# SERVICE BULLETIN

M-887

SAFETY RECALL CODE 057

## SIDECAR FRONT MOUNT

Figure 1. Vehicle Tilt Angle

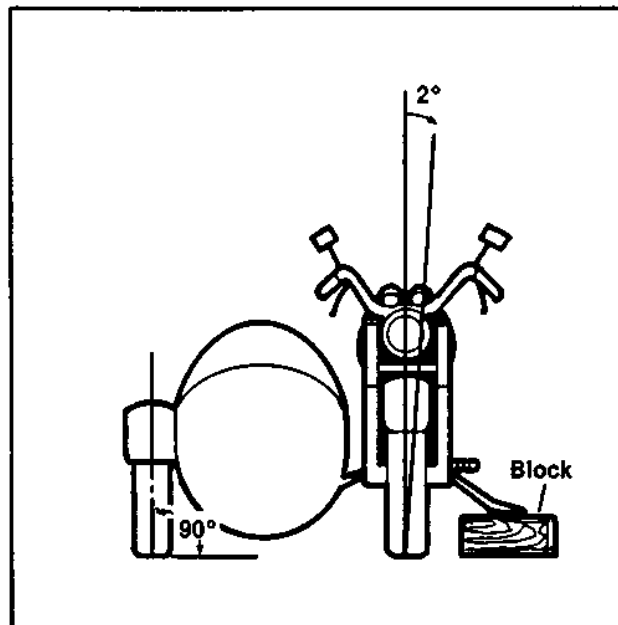
1. Place blocking under jiffy stand as shown in Figure 1.

Vehicle must be adequately supported by blocking to prevent the front brace from rotating in the clamps and damaging the damper tube when the brace is detached.

Check vehicle tilt angle with protractor. If necessary adjust sidecar front brace forward or backward in clamps so motorcycle leans approximately 2° away from sidecar. Refer to the Owner's Manual for full information on checking and adjusting vehicle tilt angle.

Figure 2. Front Upper Mount

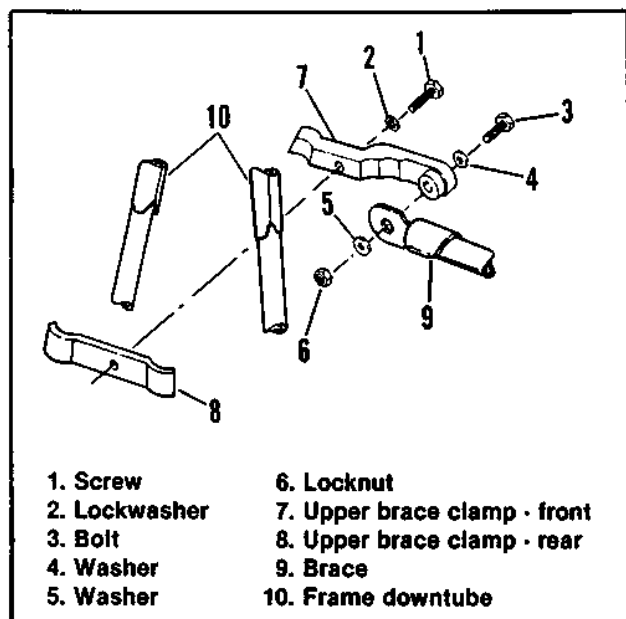
A routine inspection conducted on one of our company owned vehicles revealed a fracture at the upper clamp in the sidecar upper front mount. Further investigation and analysis of the fractured part indicated that the fracture was due to chemical impurities in the casting and improper heat treating. These conditions were acquired during the manufacturing process of our vendor.

2. See Figure 2. Detach brace (9) by removing bolt (3) nut (6) and washers (4) and (5).
3. Remove upper brace clamp front (7) and rear (8) by first removing bolt (1) and lockwasher (2).

1. Position replacement upper brace clamps front (7) and rear (8) with the center holes aligned. Place lockwasher (2) on bolt (1). Insert bolt (1) through clamp (7) and loosely thread into the tapped center hole in clamp (8).
2. Place flatwasher (4) on bolt (3). Position upper clamp assembly so outboard hole in clamp (7)

aligns with hole in brace (9). Insert bolt (3) through clamp (7) and brace (9). Place washer (5) over end of bolt (3) then thread on locknut (6).

3. Tighten bolt (1) to 50-60 ft-lbs torque.
4. Tighten bolt (3) to 70-80 ft-lbs torque.
